## STAFF REPORT

### DESIGN COMMISSION STUDY SESSION

<b>Project No:</b>	DSR20-010
<b>Description:</b>	Shell Station renovation
<b>Applicant/ Owner:</b>	Brad Kaul (Kaul Design Architecture) / Matt Randish (Sun Pacific Energy)
<b>Site Address:</b>	7833 SE 28 <sup>th</sup> St (Parcel Number 545230-0380)
<b>Zoning District</b>	Town Center (TC)
<b>Staff Contact:</b>	Robin Proebsting, Senior Planner
<b>Exhibits:</b>	<ol style="list-style-type: none"> <li>1. Conceptual Plans prepared by Kaul Design Architecture, dated February 25, 2021</li> <li>2. Project Narrative prepared by Brad Kaul</li> <li>3. Shell Convenience Store Addition Parking Memo prepared by Heath &amp; Associates, dated March 2, 2021</li> </ol>

A2.1

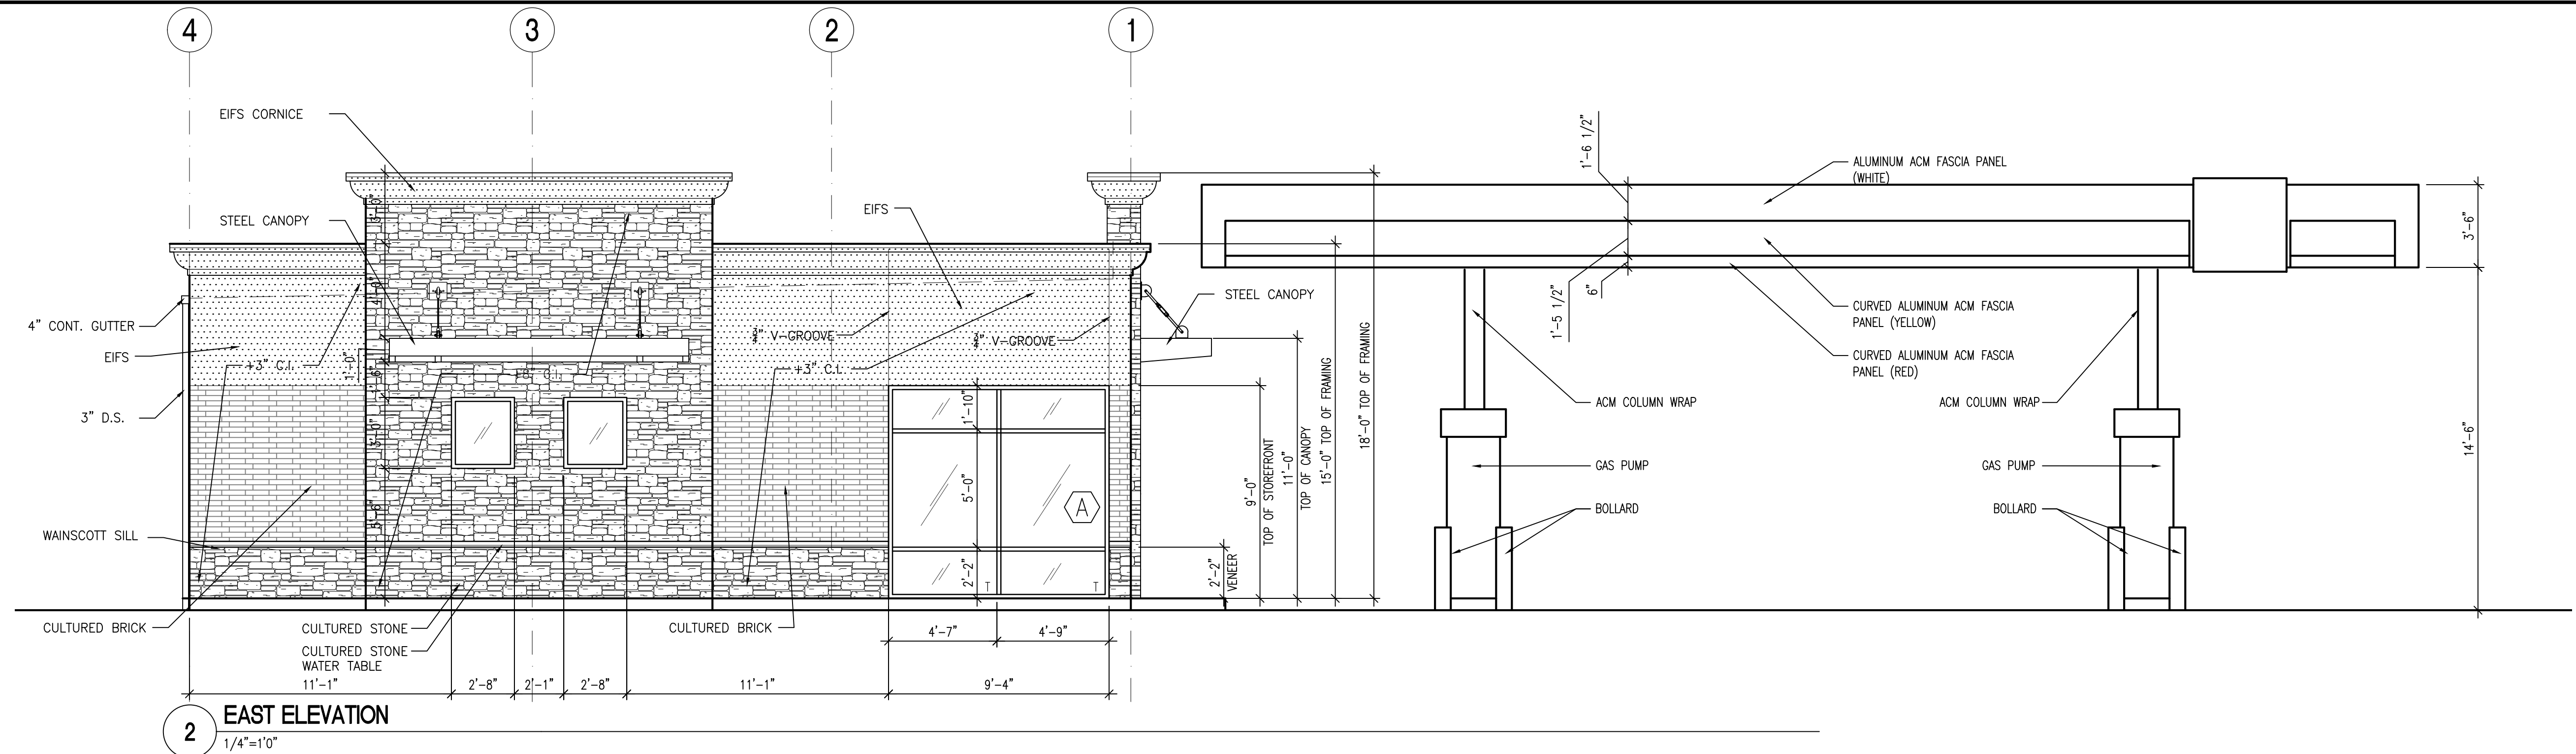
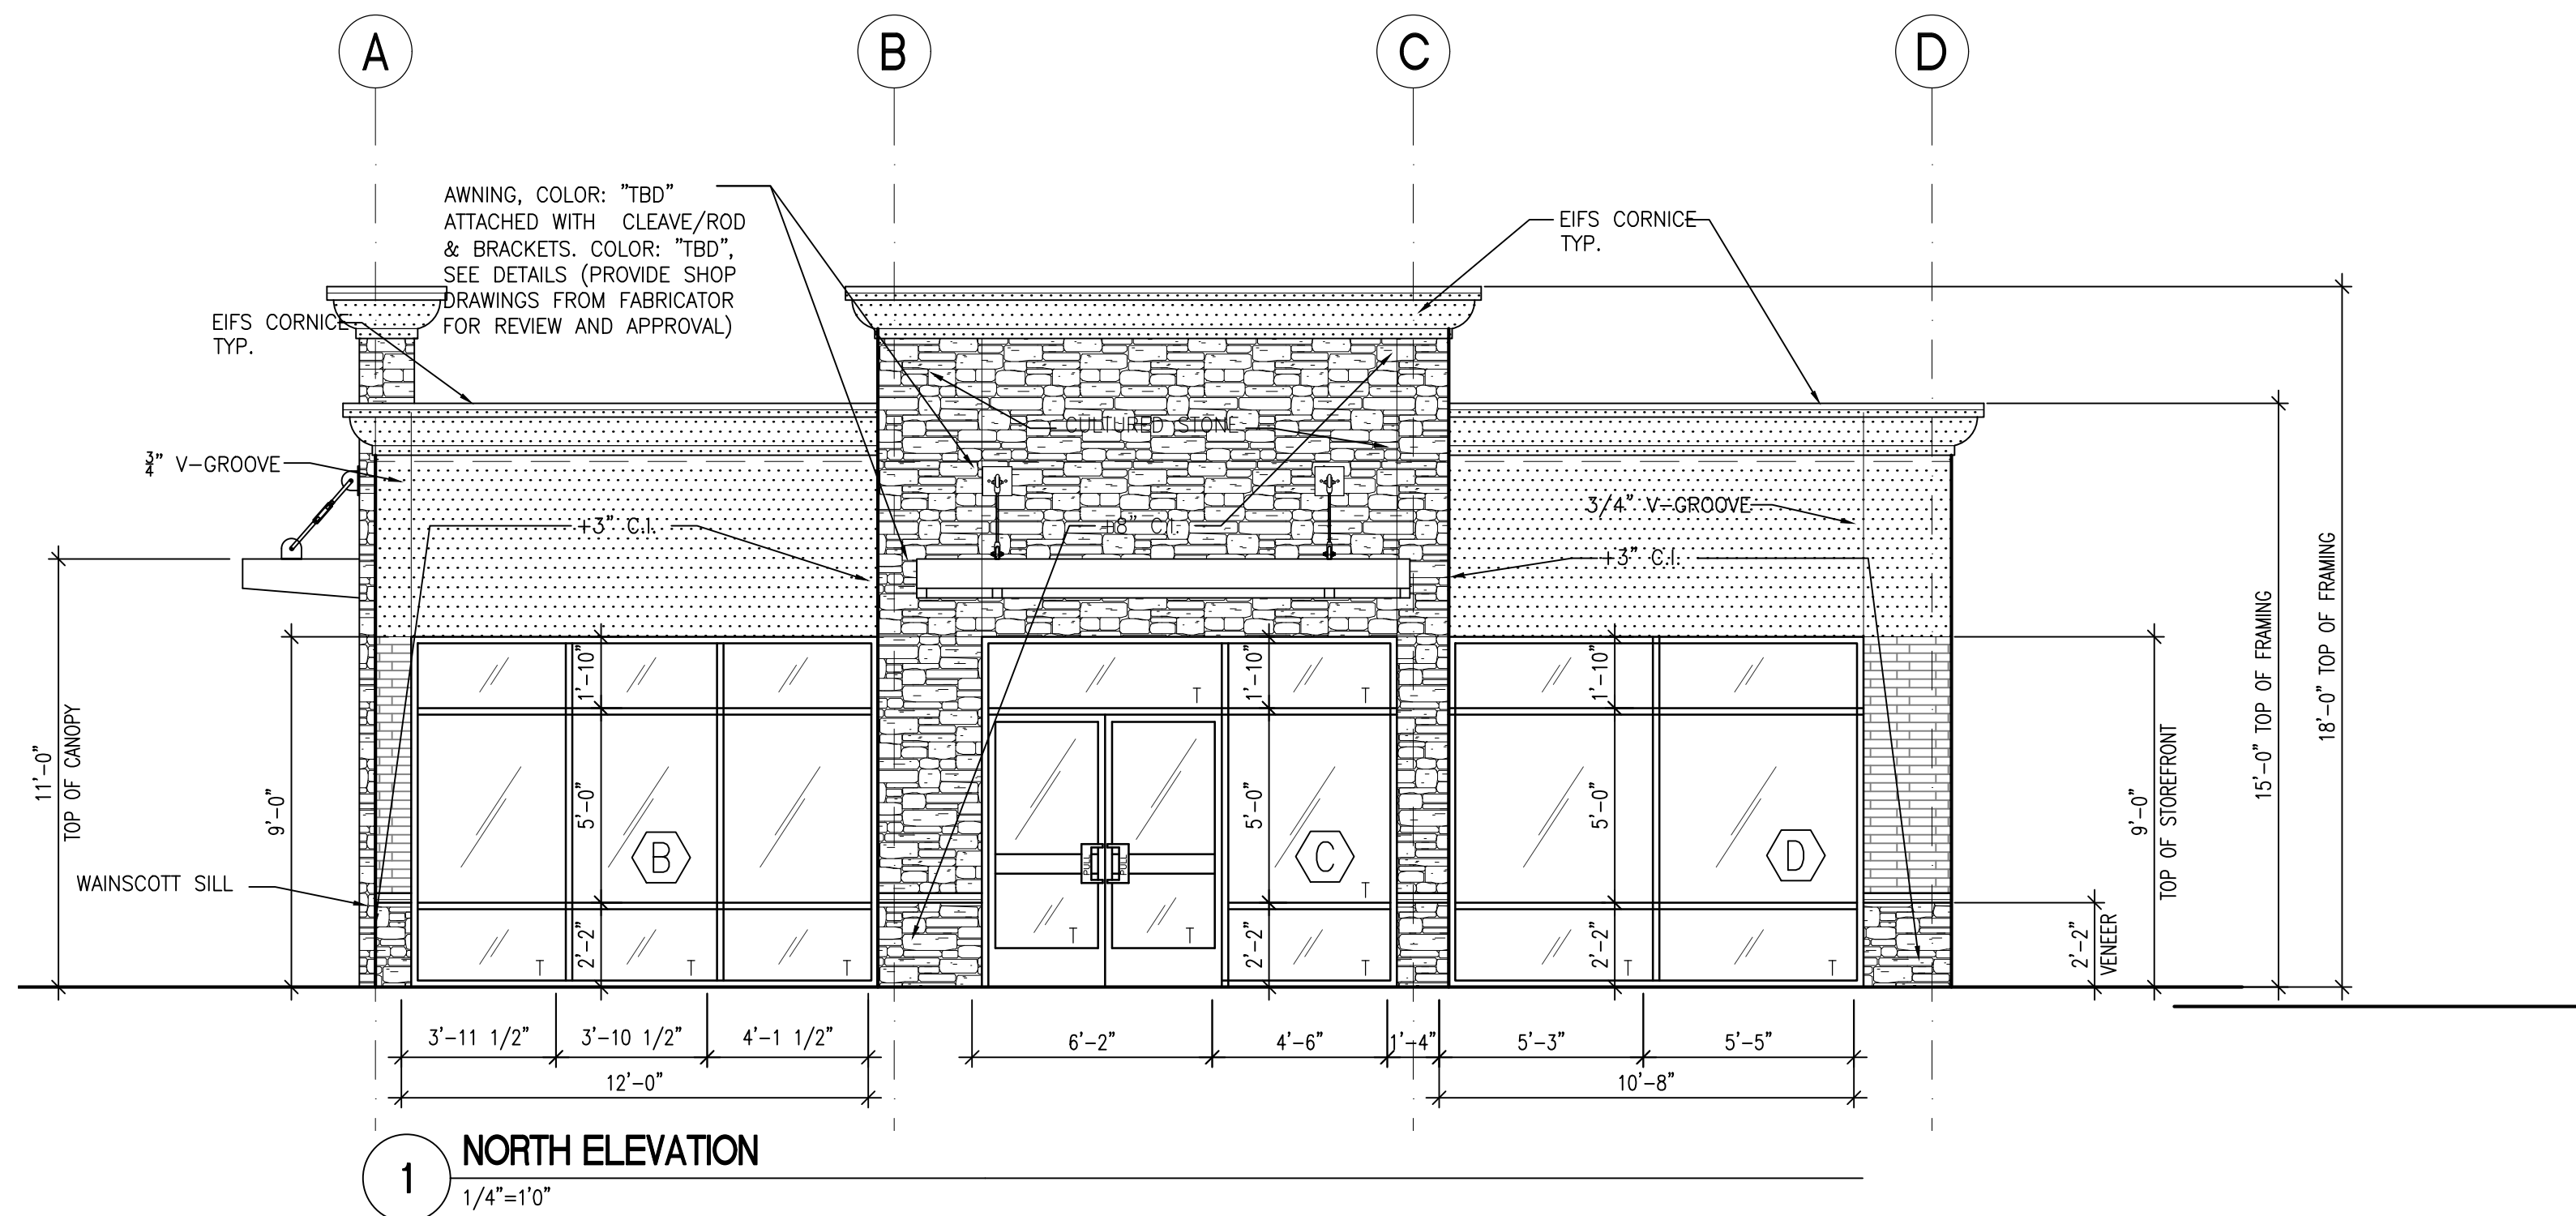
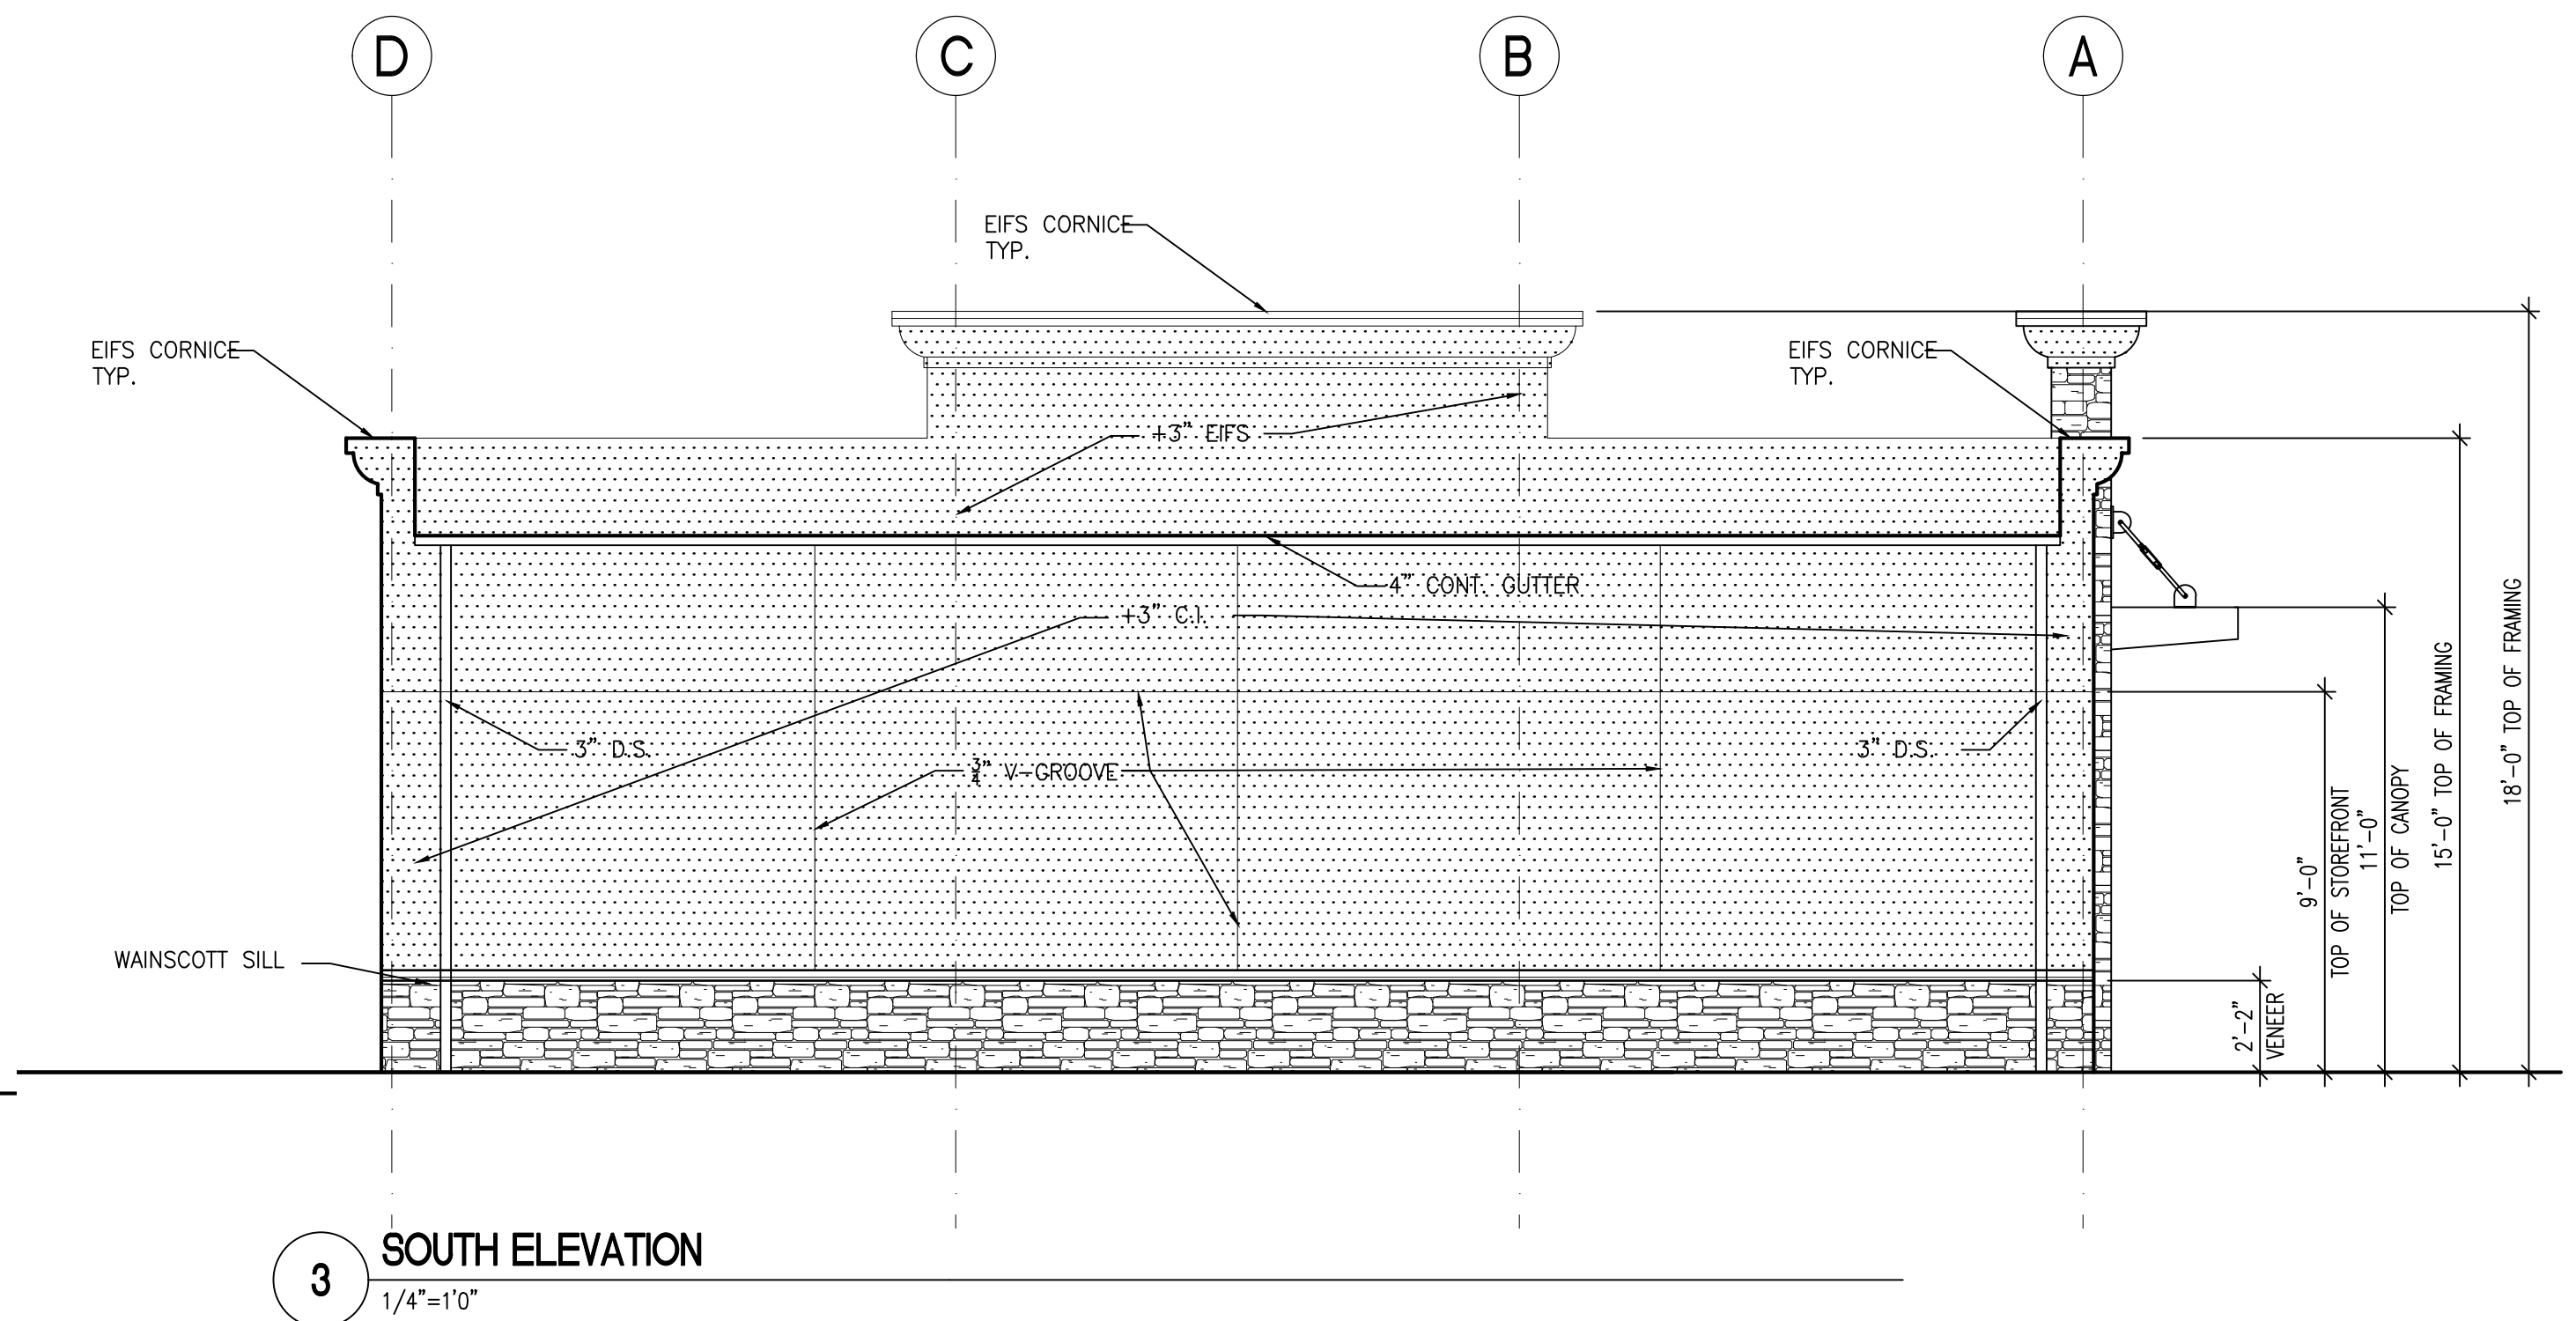
Building height is limited to 27 feet, pursuant to MICC 19.11.030(A)(1). The convenience store and fuel canopy will be 18 feet tall at their highest point, consistent with this standard (Exhibit 1, sheet A2.1).

Average Daylight Plane standards in MICC 19.11.030(A)(7) require block frontages to step back buildings at a 45-degree angle beginning at a height of 25 feet. Since all buildings will be shorter than 25 feet, this standard does not apply (Exhibit 1, sheet A2.1).

The building design section also includes a prohibition on untreated blank walls, defined as a wall (including building facades and retaining walls) over six feet in height, with a horizontal length greater than 15 feet that does not include a transparent window or door. Method to treat blank walls include 1) a landscape planting bed at least five feet wide or a raised planter bed at least two feet high and three feet wide in front of the wall with planting materials that are sufficient to obscure or screen at least 60 percent of the wall's surface within three years and 2) a vertical trellis in front of the wall with climbing vines or plant materials. The north and east elevations of the convenience store will not have any blank areas more than 15 feet in width (Exhibit 1, Sheet A2.1); the south and west elevations have blank walls greater than 6 feet by 15 feet, but these walls are partially obscured by landscaping along the south and west property lines. This item will be a discussion item at the May 13<sup>th</sup> study session.

bright colors only for trim or accent areas. The proposed material palette will use a complimentary mix of earth-toned materials, with bright colors used only to accent the Shell logo on the fuel canopy. The proposed design utilizes EIFS, which is listed as an undesired material in MICC 19.11.110(B)(7) that should be limited to use as a minor building façade element. Recall that when a standard uses the word “should,” the standard is mandatory unless the applicant can demonstrate, to the satisfaction of the design commission, an equal or better means of satisfying the standard and objective. The Design Commission has the discretion to allow the broader use of EIFS for this project if it determines that the objectives in MICC 19.11.110(A) are met, which include use of textured, high-quality materials that bring a visually interesting experience into the streetscape. This item will be a discussion item at the May 13<sup>th</sup> study session.

Town Center sign standards are contained in MICC 19.11.140 and allow one sign per business on each street frontage. A sign is defined as: “Any series of letters, figures, design symbols, lights, structure, billboard, trademark or device intended or used to attract attention to any activity, service, place, subject, person, firm, corporation, or thing”. Staff understand the Shell logo to fall into the definition of “sign”, therefore the proposed design will need to be modified to remove one of the two proposed signs on the east elevation.
